La Marzocco Technical Bulletin #48 - NEW LINEA AV STANDARD GIGGLERS

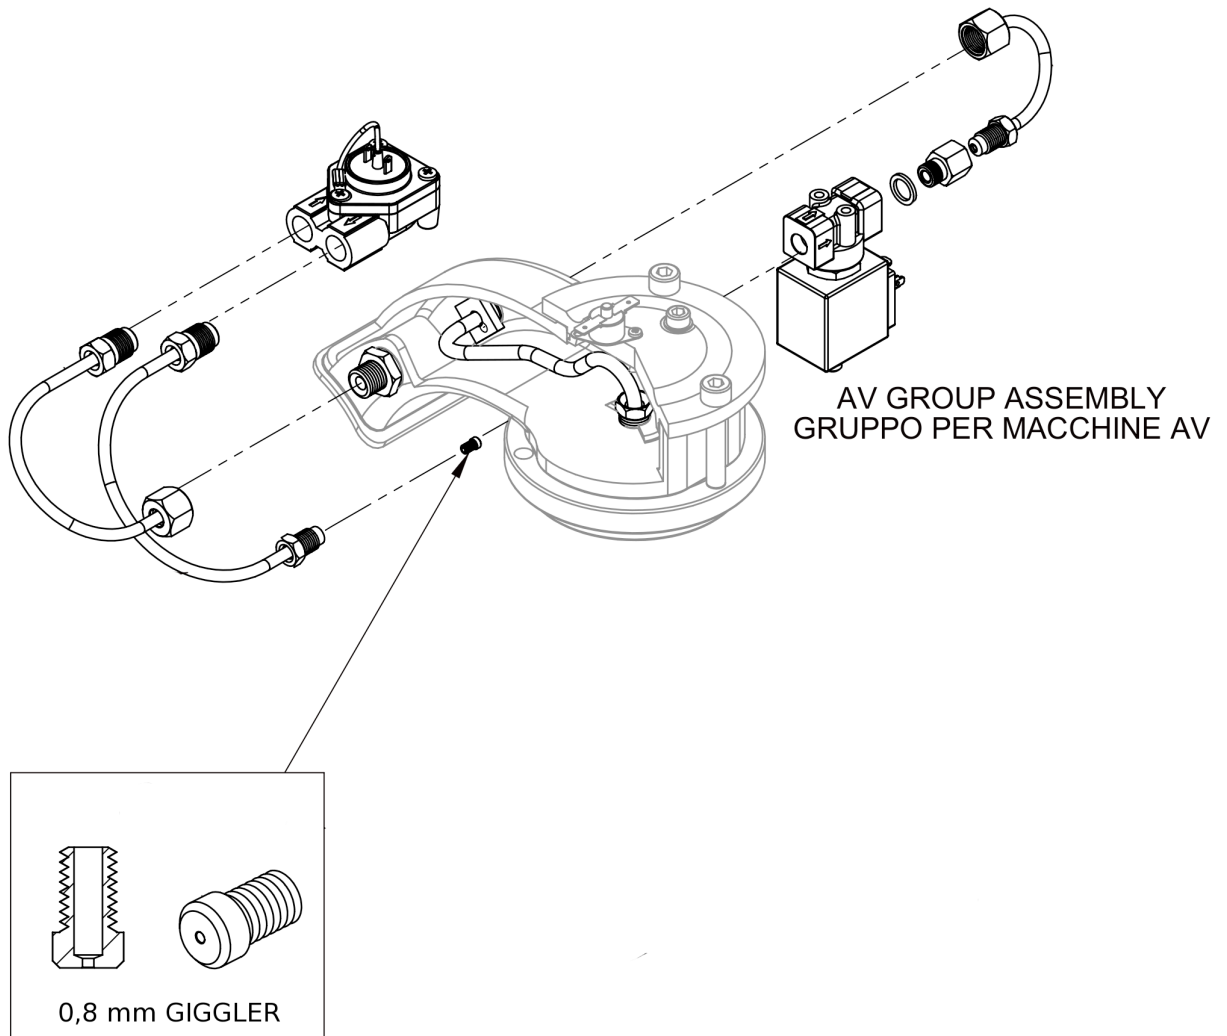
Herewith we would like to inform you about the latest modification on our LINEAS & FB/70 AV: after machine s/n 32595, ALL MACHINES are equipped with a new standard giggler, size 0,8 mm.

The giggler (# L087/GI8) will set the group flow-rate at around 700-800 ml/min, consequently allowing a better pre-infusion.
